City of St. Augustine

Historic Architectural Review Board

A G E N D A

Thursday, August 15, 2019 1:00 p.m.

Sheet
Number

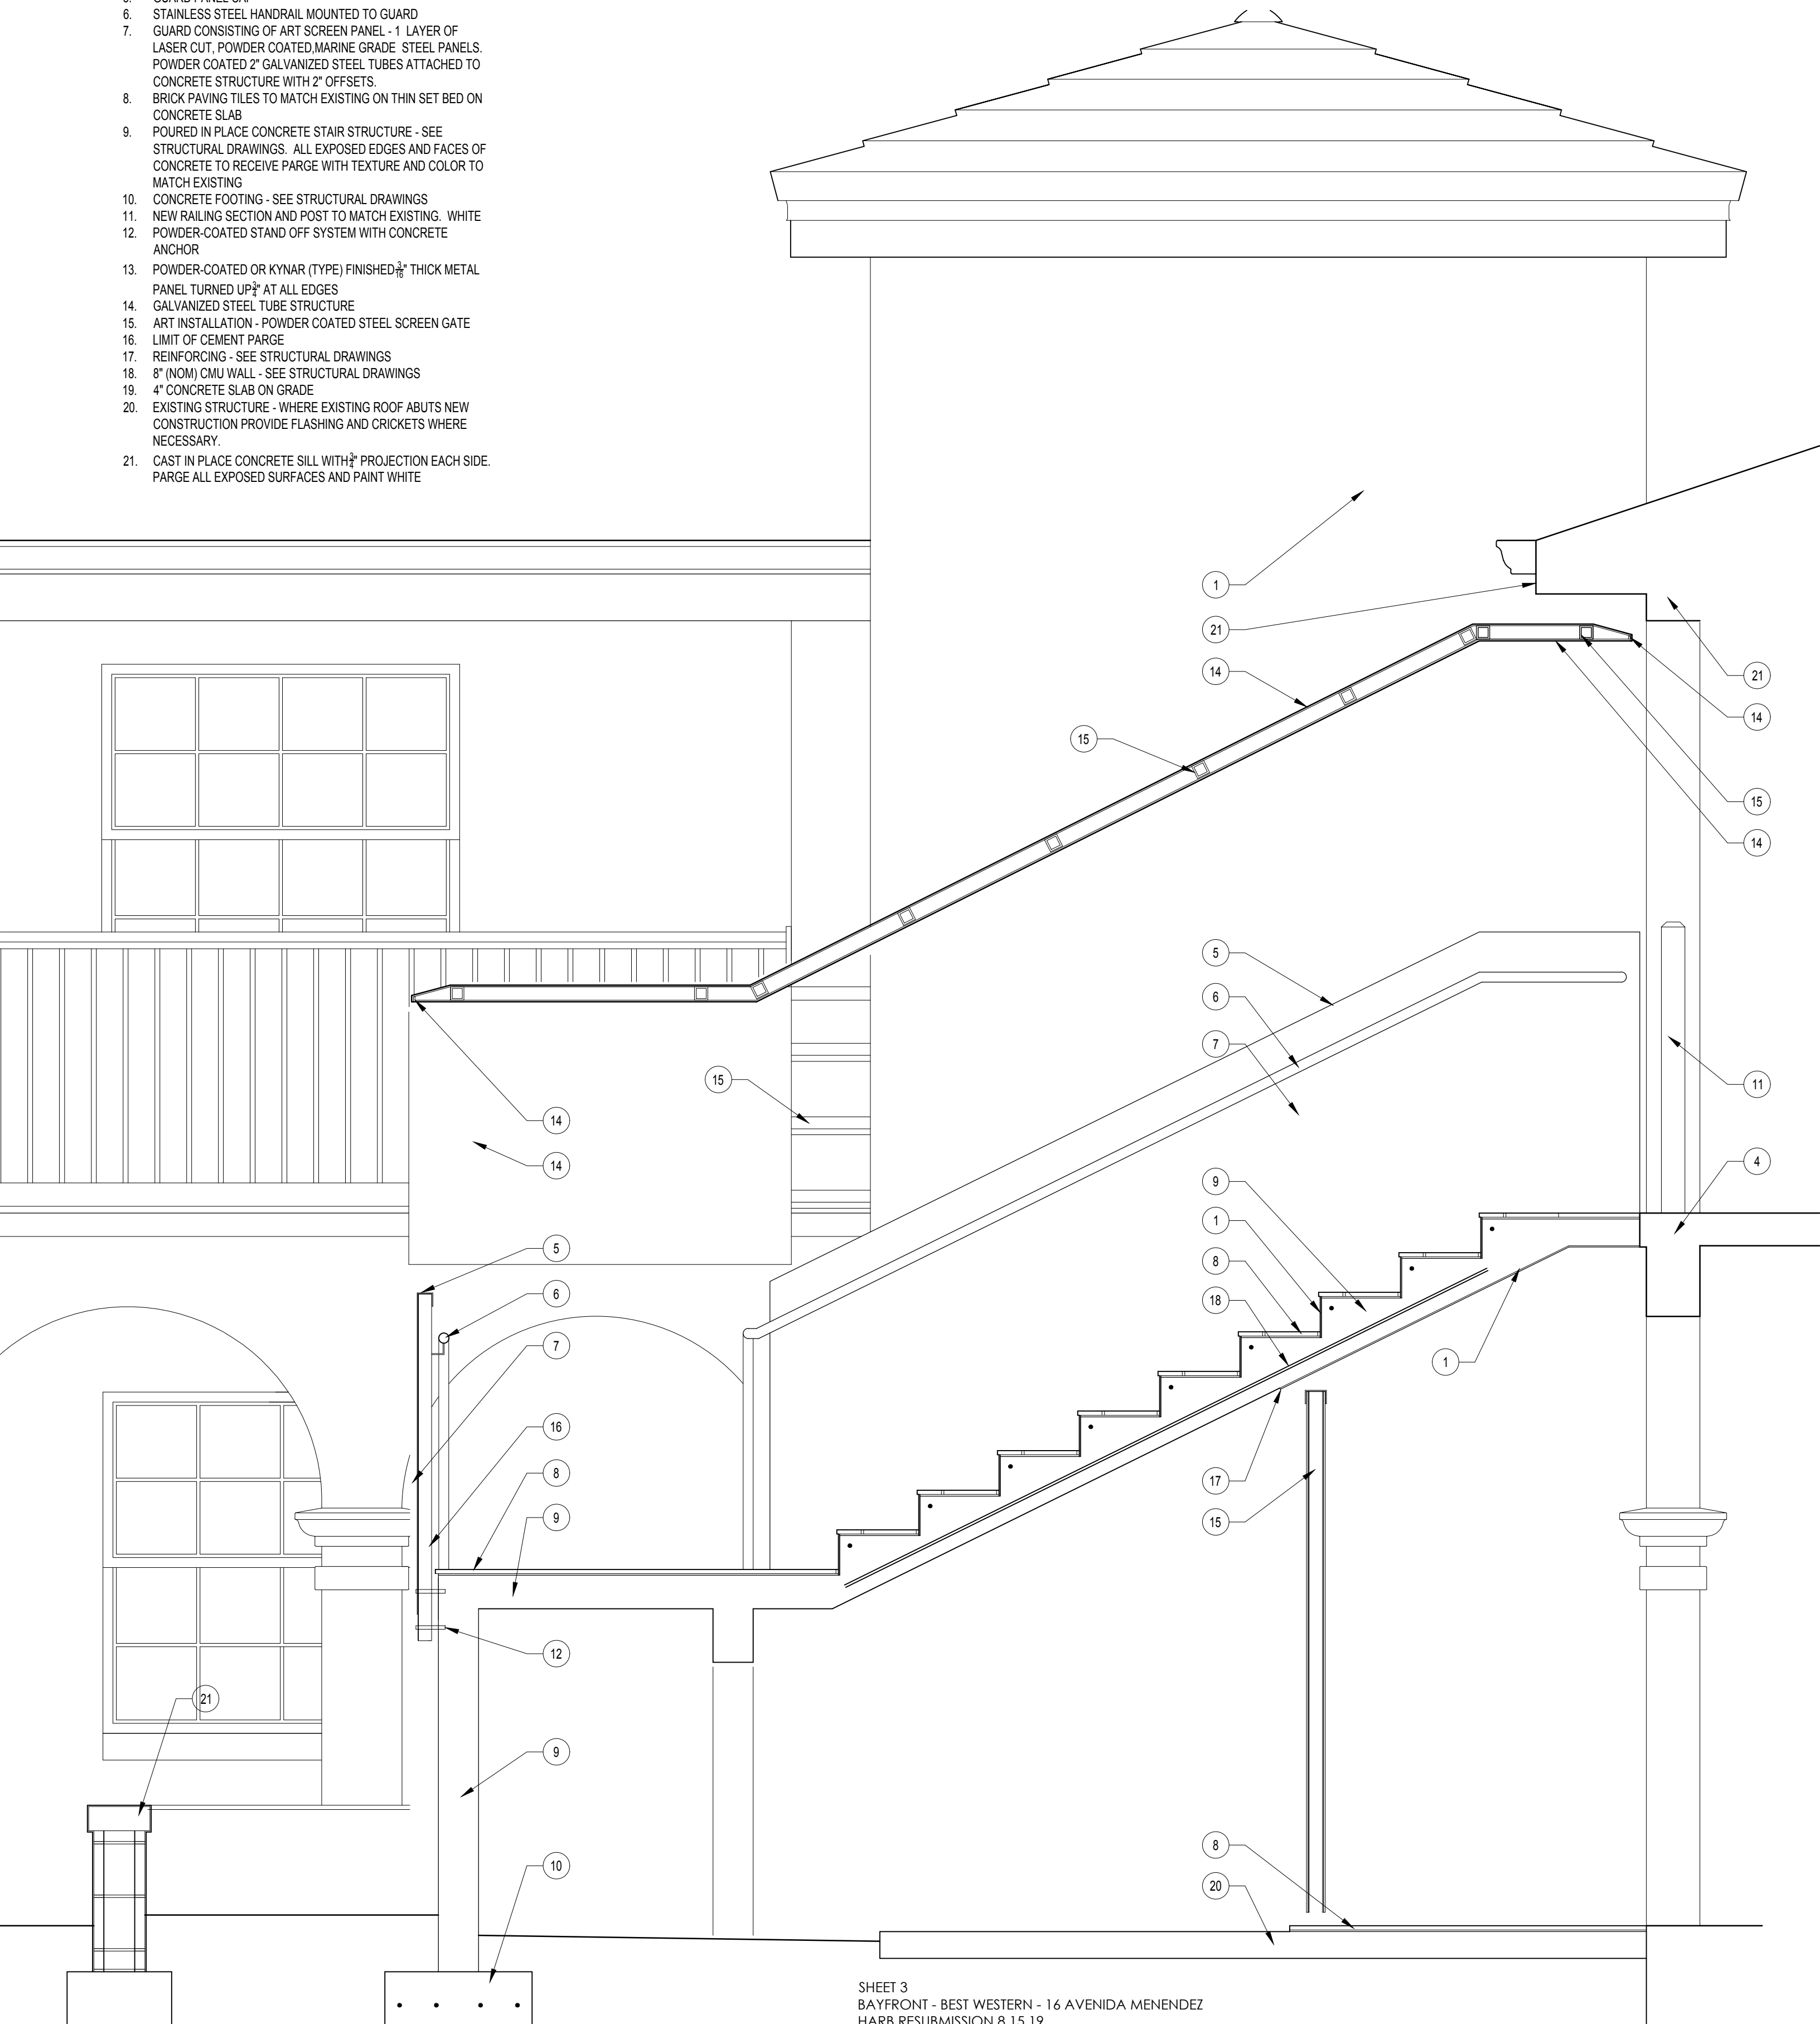
- Is the metal art for the stairs backed with anything? It appears that you can see through it, and I wanted to verify.

- Did you make a change to the canopy?

The shape is the same - we simplified it by removing the rubber type roof. It is all metal now - in keeping with the metal handrails. Sorry this was not in the cover letter description - I updated the detail on the section drawing.

DATE: 6-20-19
SCALE: AS NOTED
DWG: DWG/243CHAR
SHEET
A-2

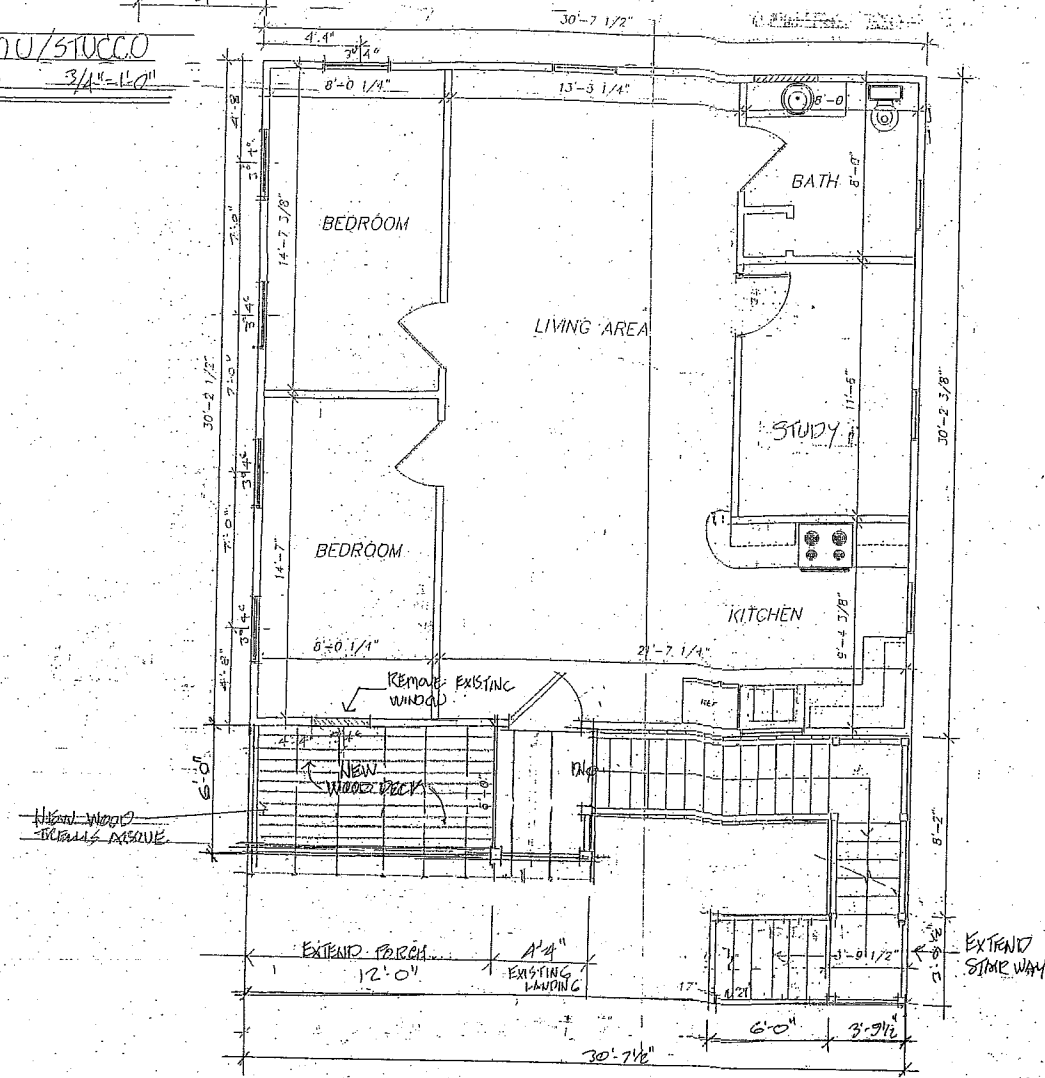
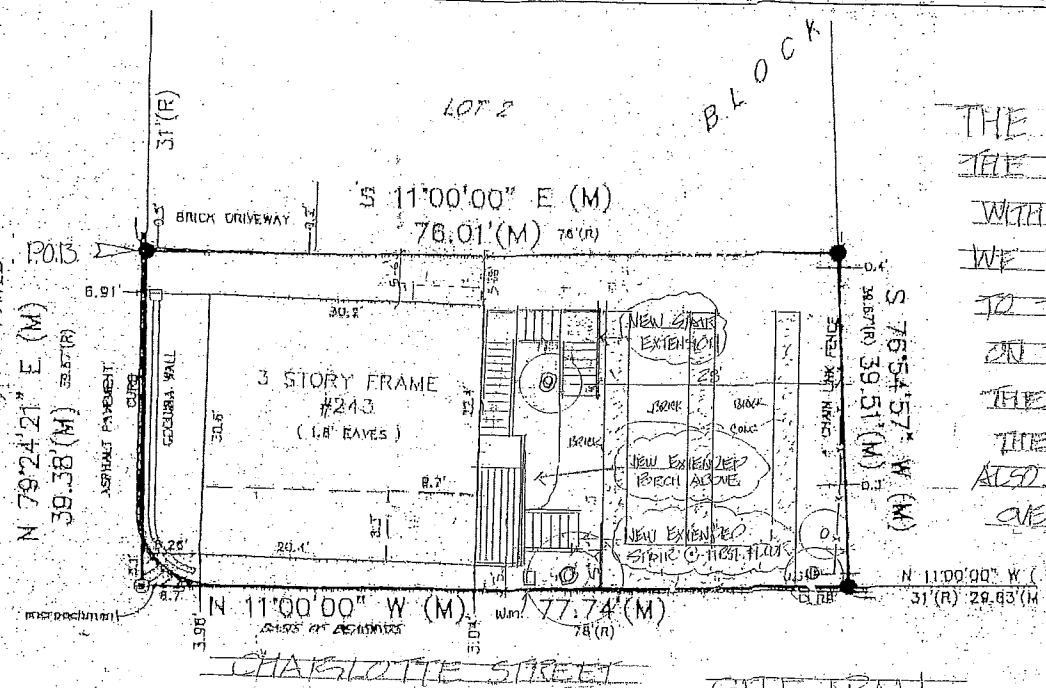
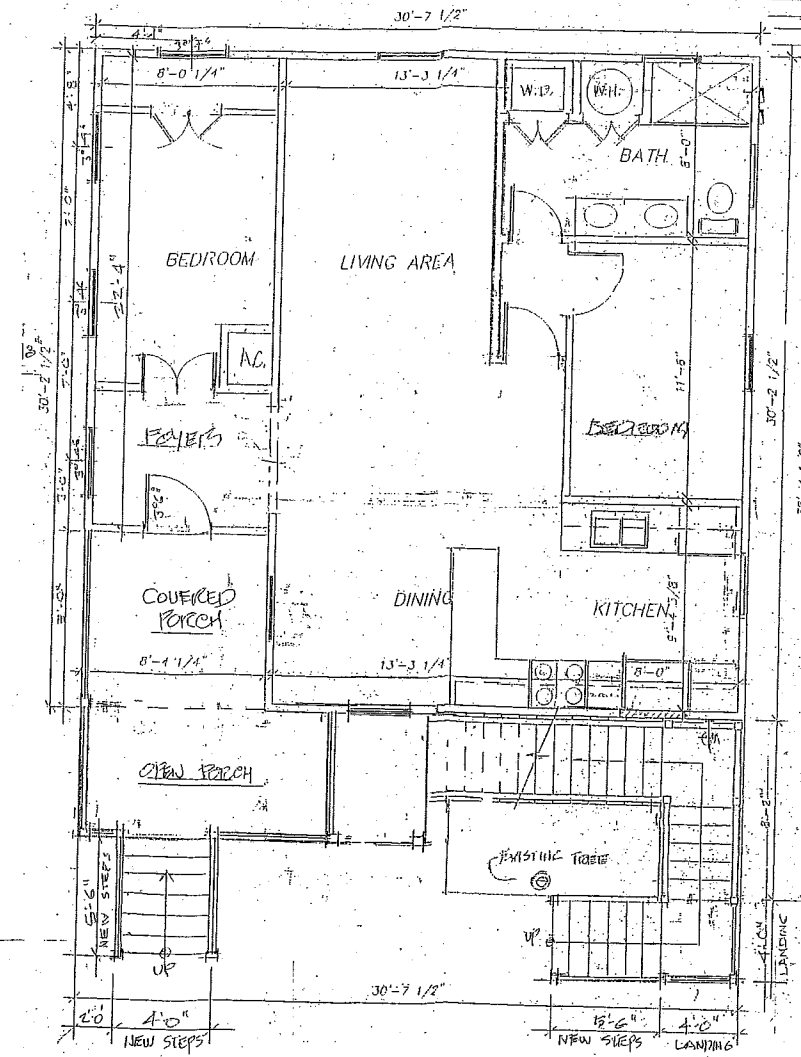
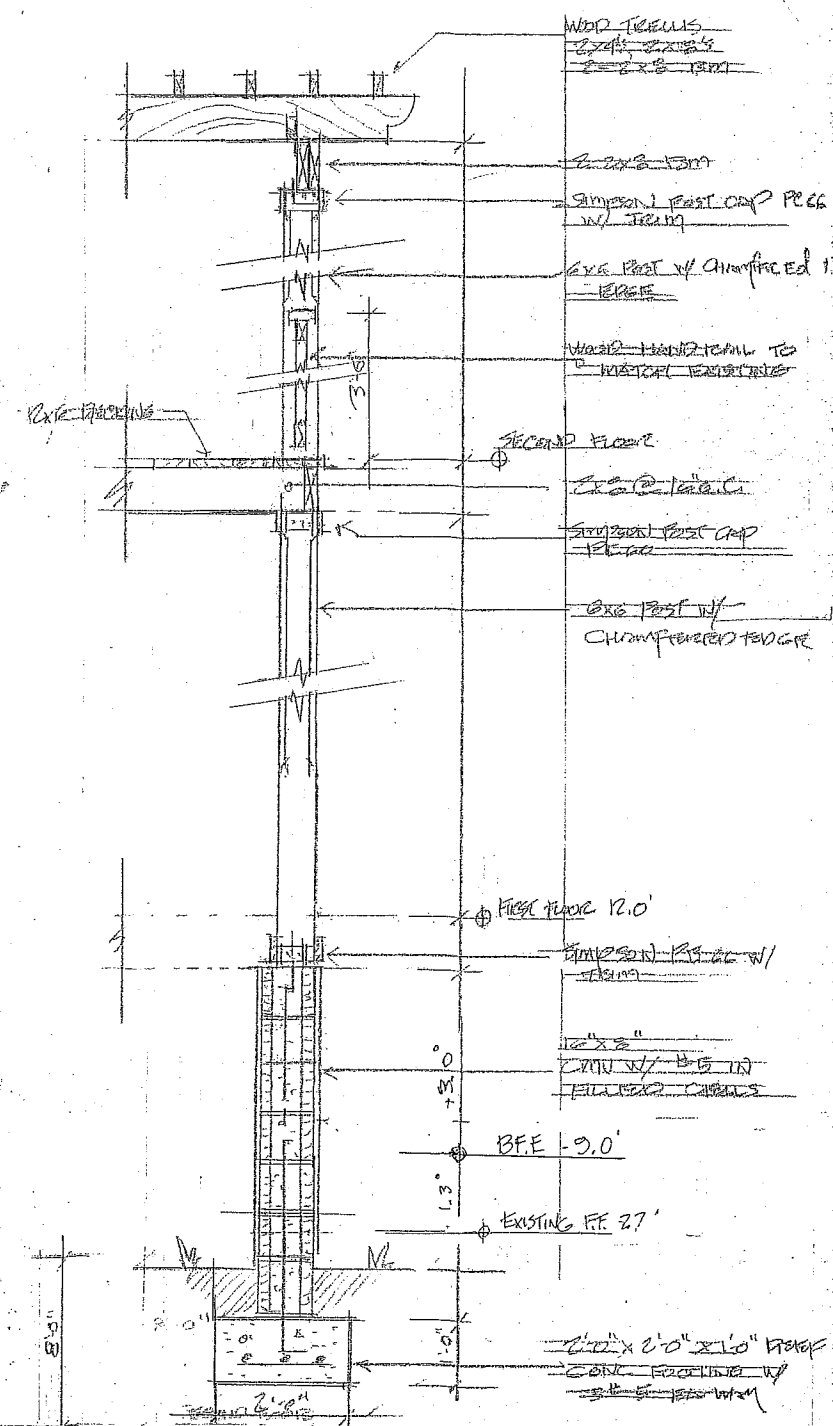
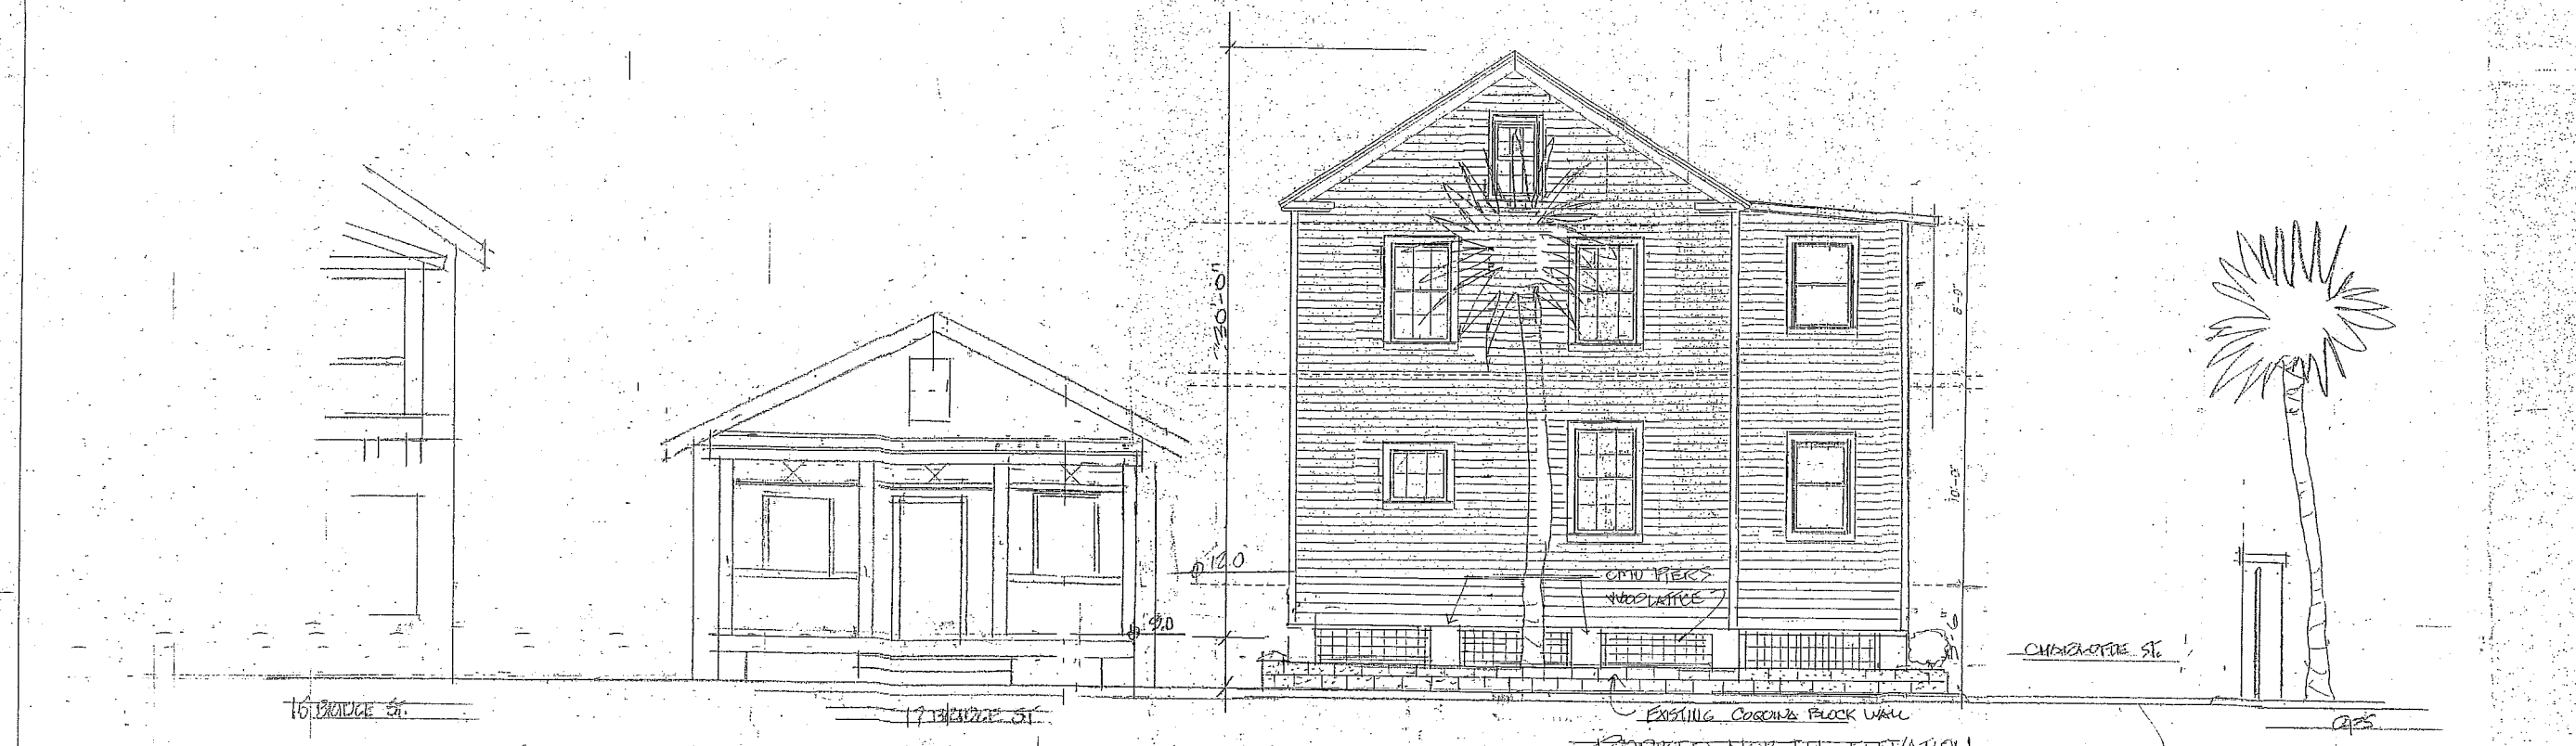
- All the design elements except for raising the building were approved at the July HARB meeting.
- The applicant brought down the siding by two feet. This reduced the amount of foundation that is visible from the street (from 5' 6" to 3' 6"). This was suggested by the board at the previous meeting and helps limit some of the visual impact of raising the structure, especially when compared to some of the surrounding buildings.
- Concrete masonry foundations are not appropriate for Frame Vernacular buildings.
- Detailing such as the plants around the foundation were provided with the application as per board comments.
- Alternatives to the raising the structure to BFE plus three were not provided.
